UNITED STATES PATENT AND TRADEMARK OFFICE

| APPLICATION NO. | FILING DATE | FIRST NAMED INVENTOR | ATTORNEY DOCKET NO. | CONFIRMATION NO. |
|---|-------------|----------------------|---------------------|----------------------|
| 10/552,532 | 10/11/2005 | Yasushi Hayashi | MAT-8748US | 4368 |

| Office Action Summary | Application No. | Applicant(s) | |

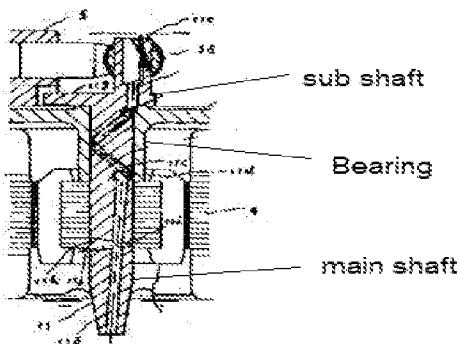
- A **hermetic container (2)** for accommodating the motor (4) and the compressing mechanism (2) and for pooling **lubricant (7)**
- A shaft having a main shaft and sub shaft (shown below)

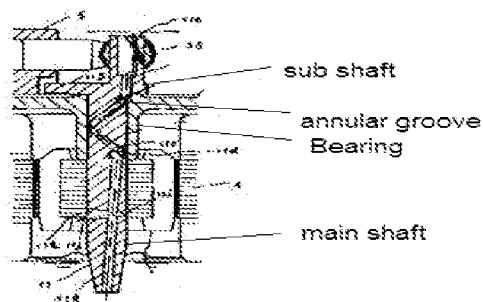
- A **cylinder (5)** for forming a compressing chamber
- A bearing (shown below) for supporting the main shaft

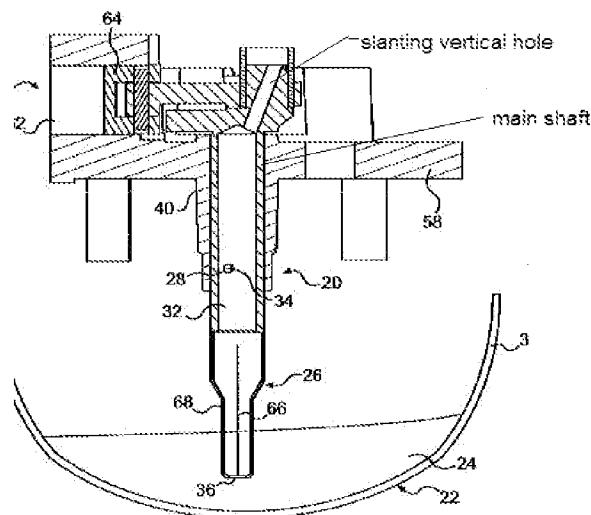
- Lead of the reverse leading groove is greater than that of the forward leading groove in **column 7,lines 10-11 and line 35-38**.Please note that the angle of the reverse (or forward) leading groove with respect to a plane perpendicular to an axis of the main shaft is interchangeable with the Lead.In addition it would have been obvious to

one skilled in the art at the time the invention was made to make the angle of the reverse leading groove to be larger than that of the forward groove simply because the lubricant oil has to go up the hill in the forward leading groove (thus it has to be small to ensure proper flow) while the lubricant oil is assisted by gravity in the reverse rotation and thus to utilize the gravity effect the groove should as much as possible be going close to 90 degree still making sure that the flow remains in the groove.
